**RECONSTRUCTION OF ENCINA AVENUE
FROM MIDDLEFIELD ROAD TO END**

**COUNTY PROJECT NO. RW703
PROJECT FILE NO. E5044000**

ADDENDUM NO. 1

NOT TO SCALE

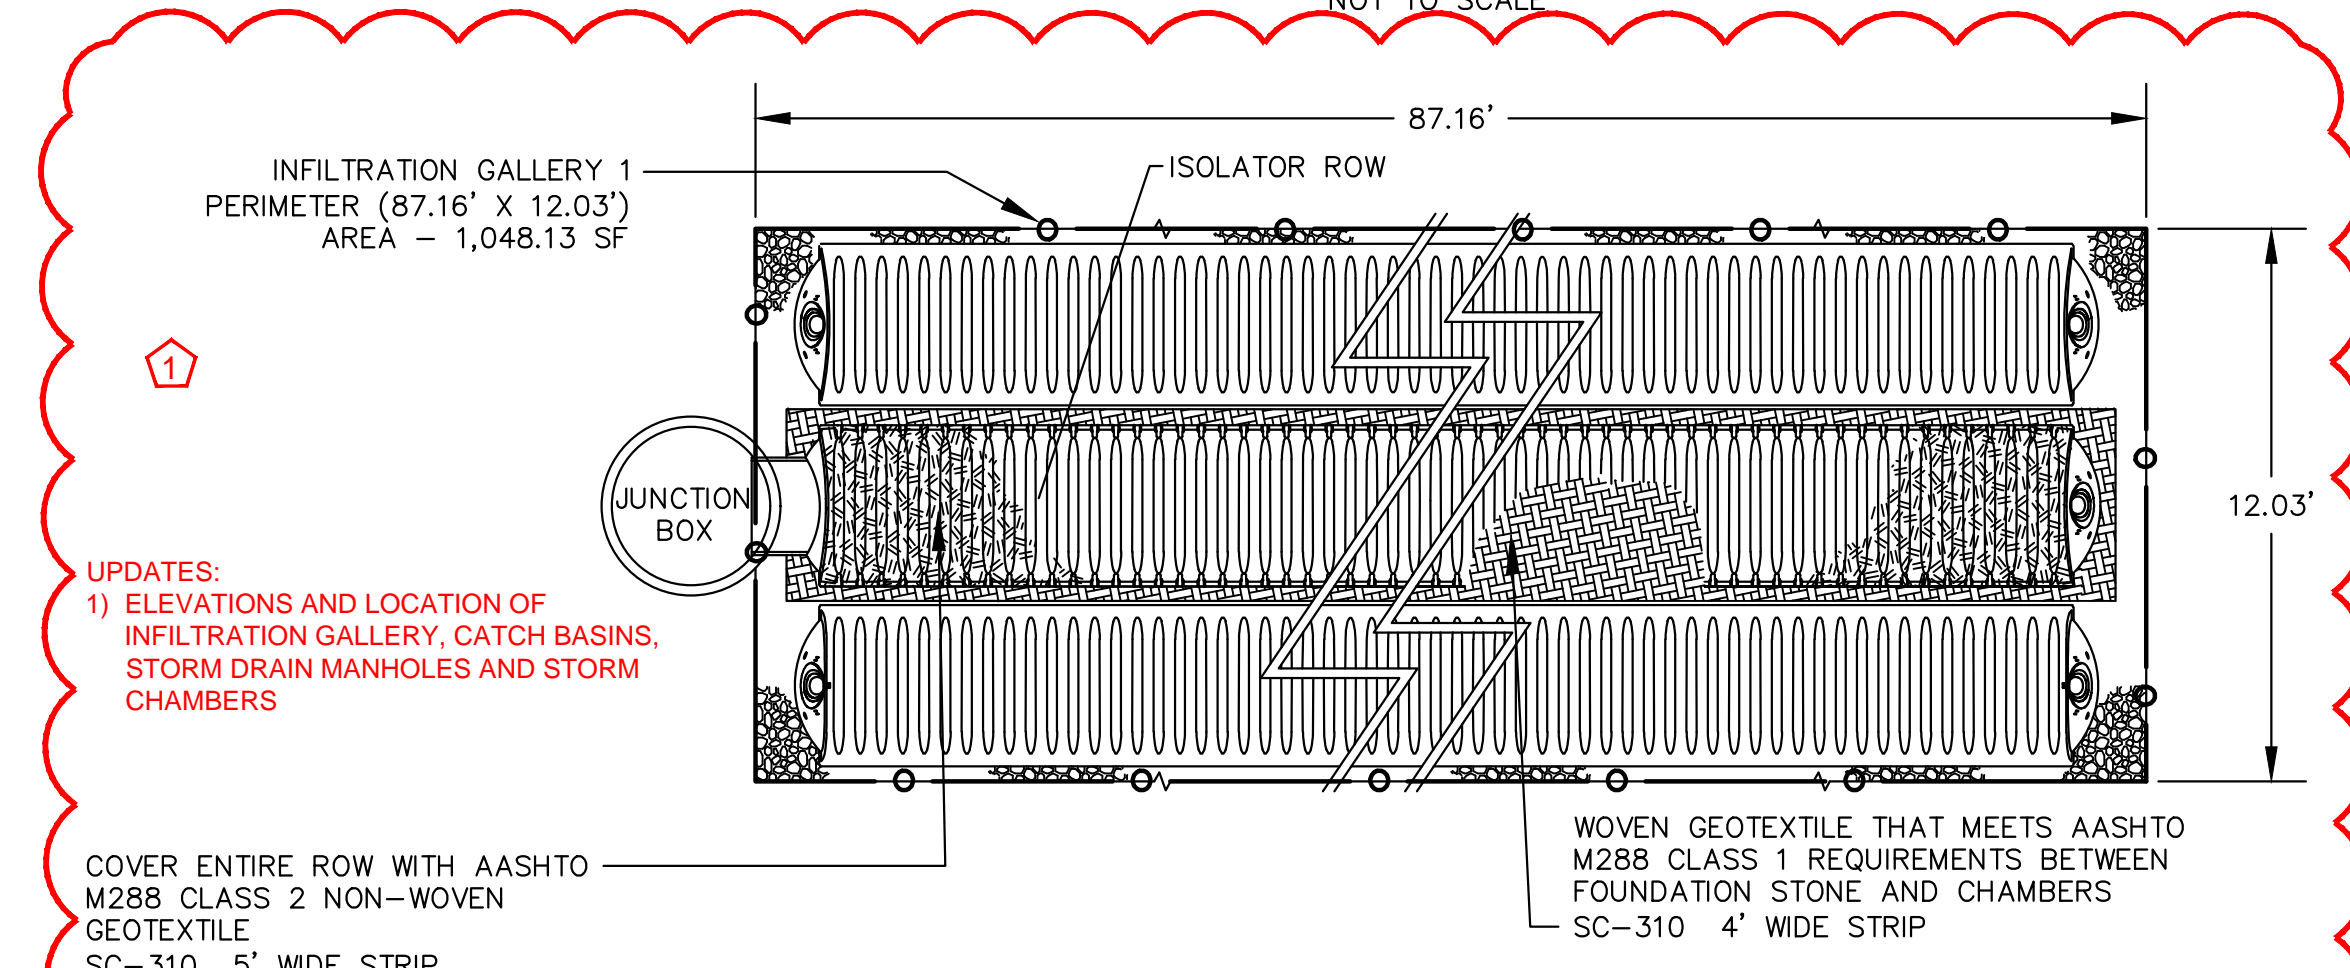
- UPDATES:**
1) ELEVATIONS AND LOCATION OF INFILTRATION GALLERY, CATCH BASINS, STORM DRAIN MANHOLES AND STORM CHAMBERS

RECONSTRUCTION OF ENCINA AVENUE FROM MIDDLEFIELD ROAD TO END INFILTRATION GALLERY 1 & 2

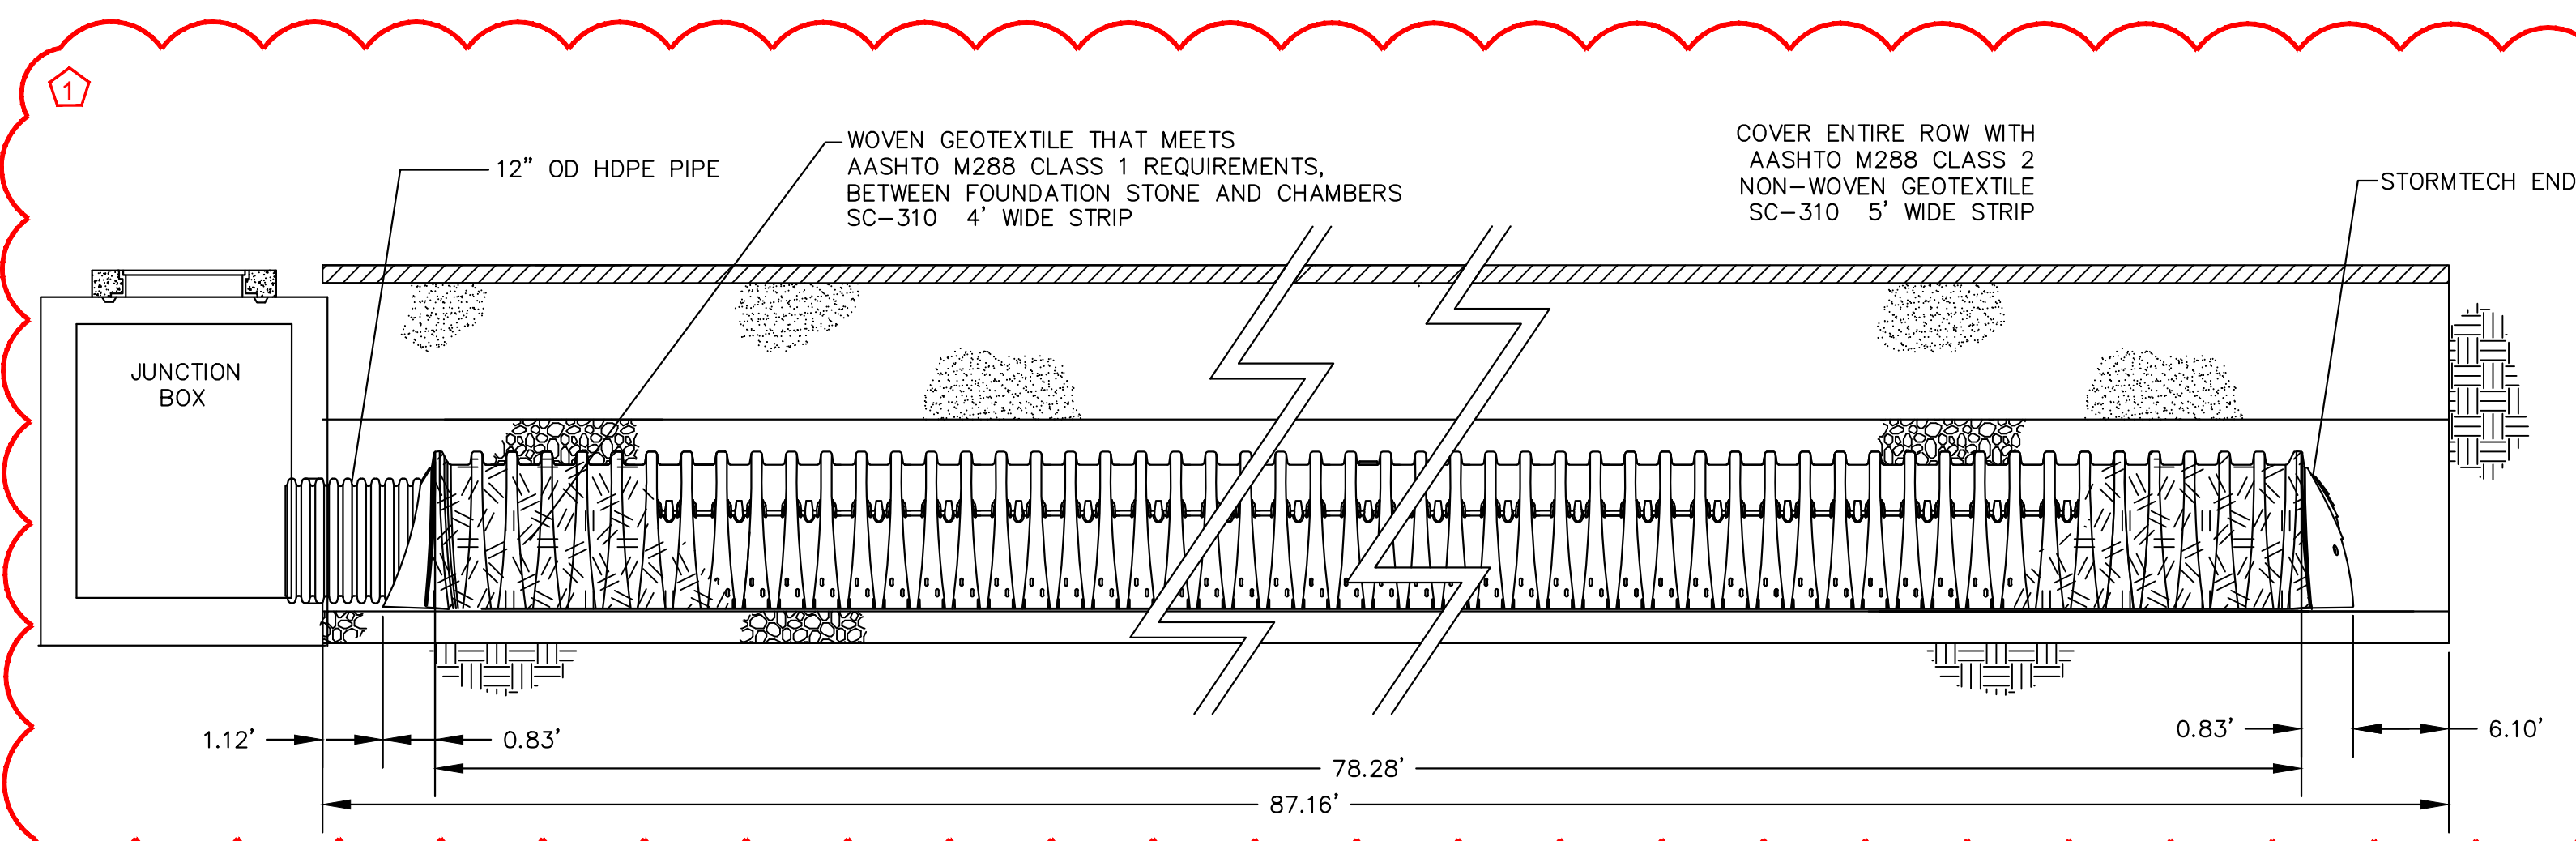
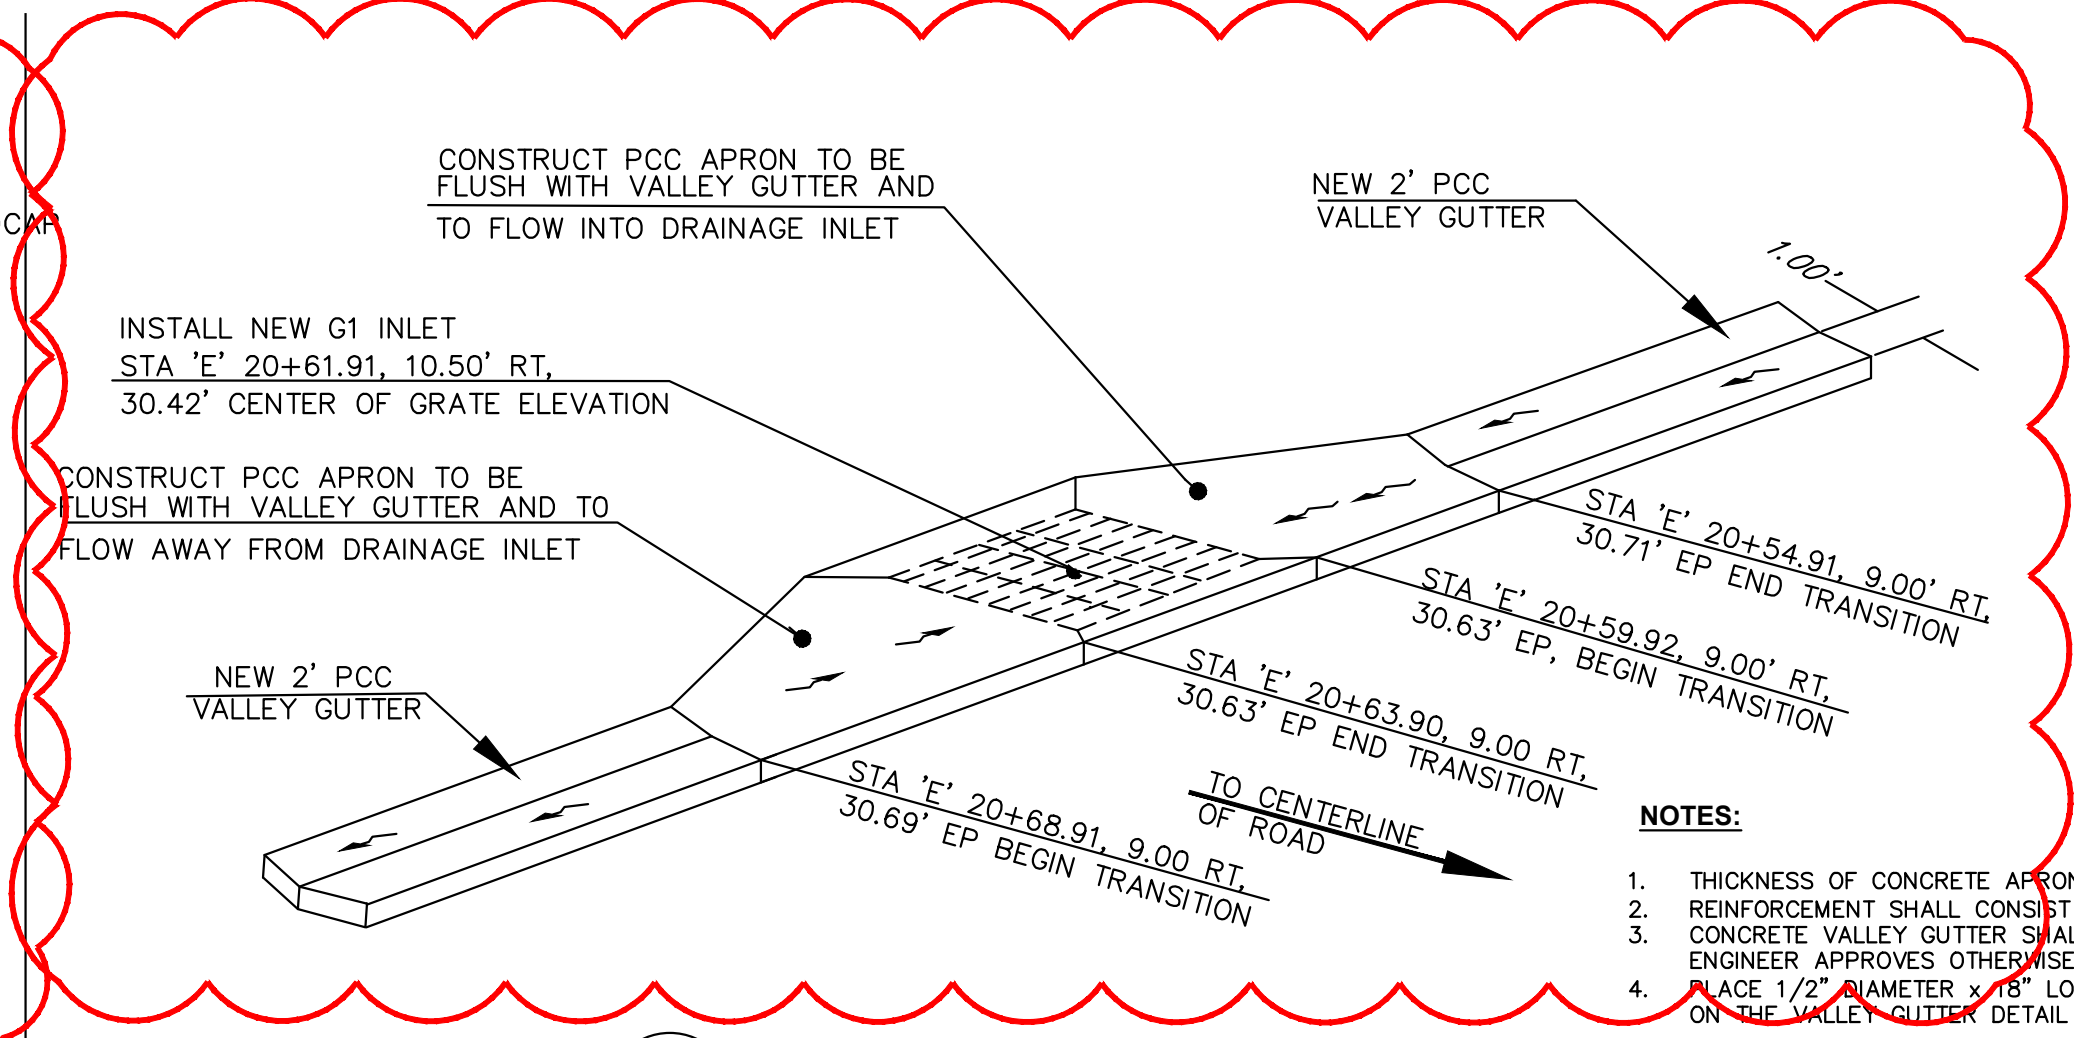
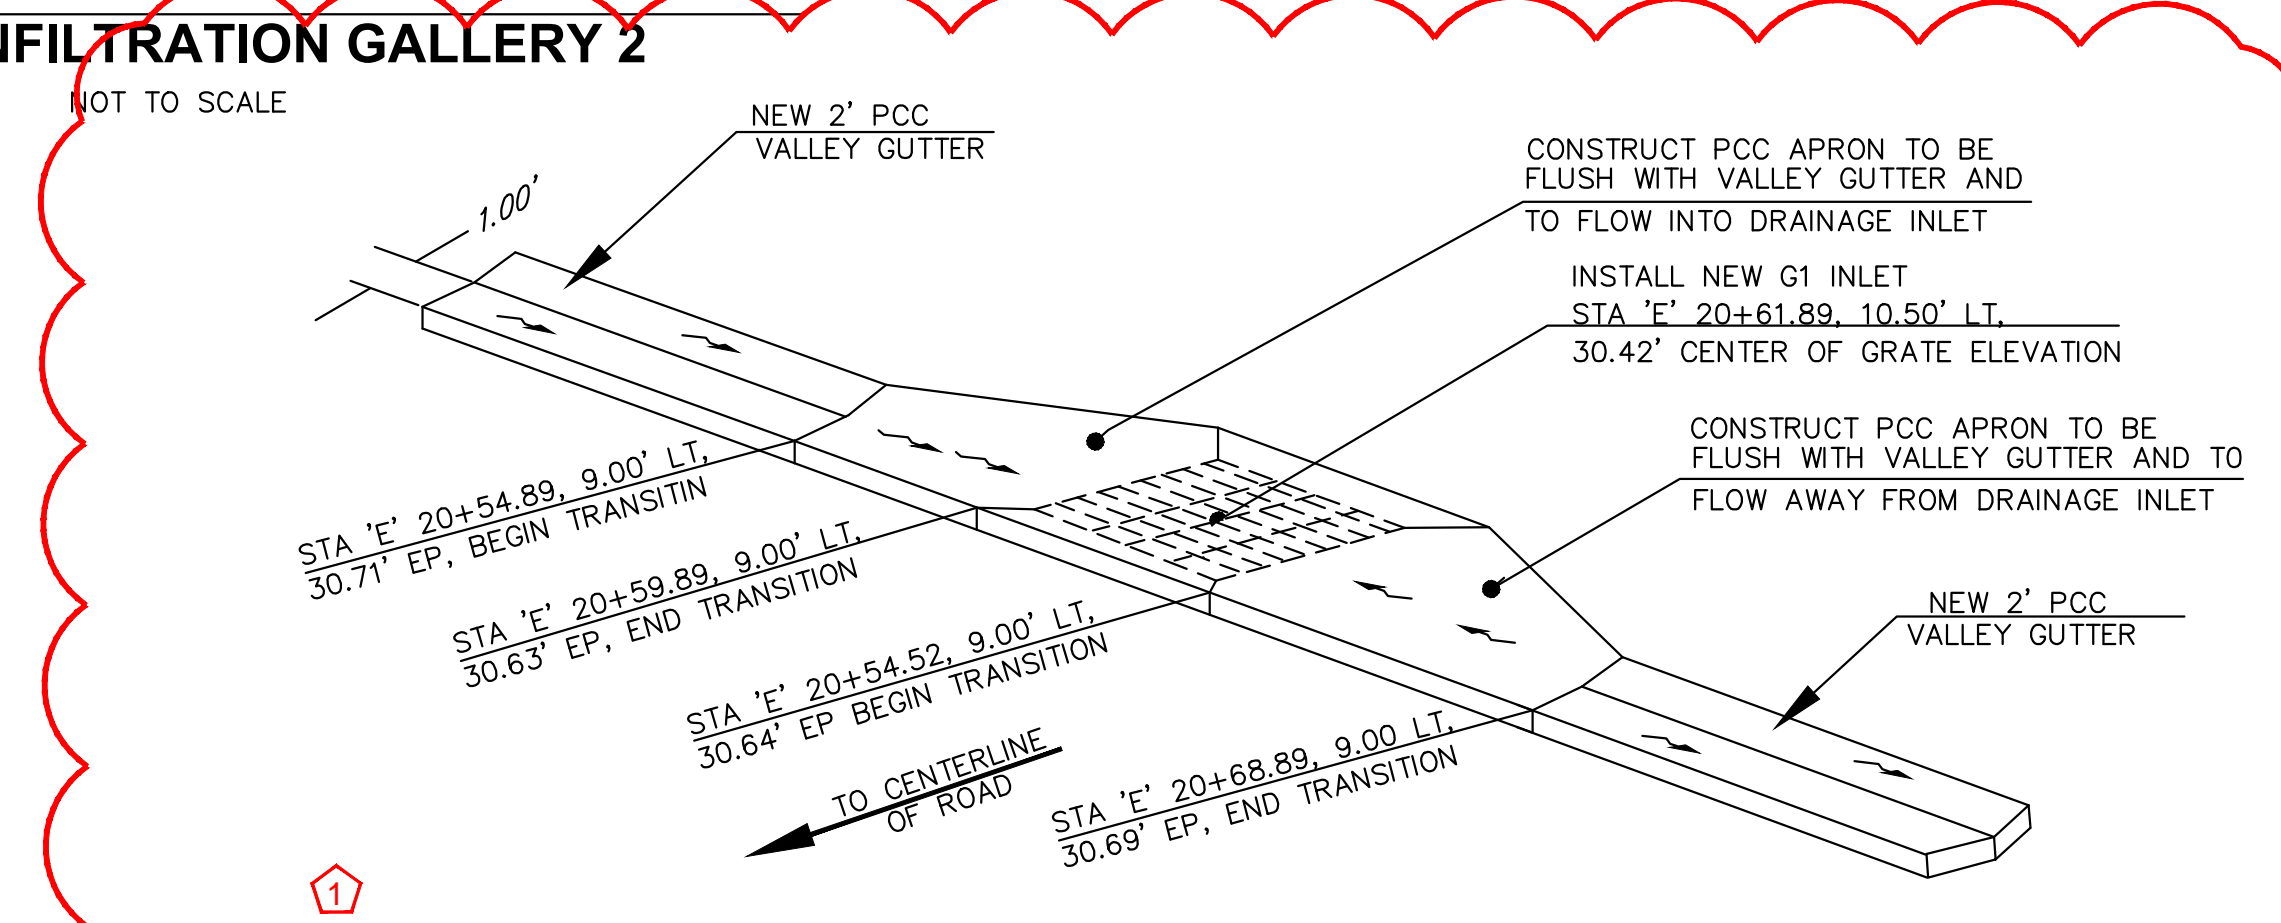
UPDATES:
 1) LENGTH, ELEVATIONS AND LOCATION OF INFILTRATION GALLERY, CATCH BASINS, STORM DRAIN MANHOLES AND STORM CHAMBERS

UPDATES:
 1) LENGTH, ELEVATIONS AND LOCATION OF INFILTRATION GALLERY, CATCH BASINS, STORM DRAIN MANHOLES AND STORM CHAMBERS

UPDATES:
 1) LENGTH, ELEVATIONS AND LOCATION OF INFILTRATION GALLERY, CATCH BASINS, STORM DRAIN MANHOLES AND STORM CHAMBERS

UPDATES:
 1) LENGTH, ELEVATIONS AND LOCATION OF INFILTRATION GALLERY, CATCH BASINS, STORM DRAIN MANHOLES AND STORM CHAMBERS

UPDATES:
 1) LENGTH, ELEVATIONS AND LOCATION OF INFILTRATION GALLERY, CATCH BASINS, STORM DRAIN MANHOLES AND STORM CHAMBERS
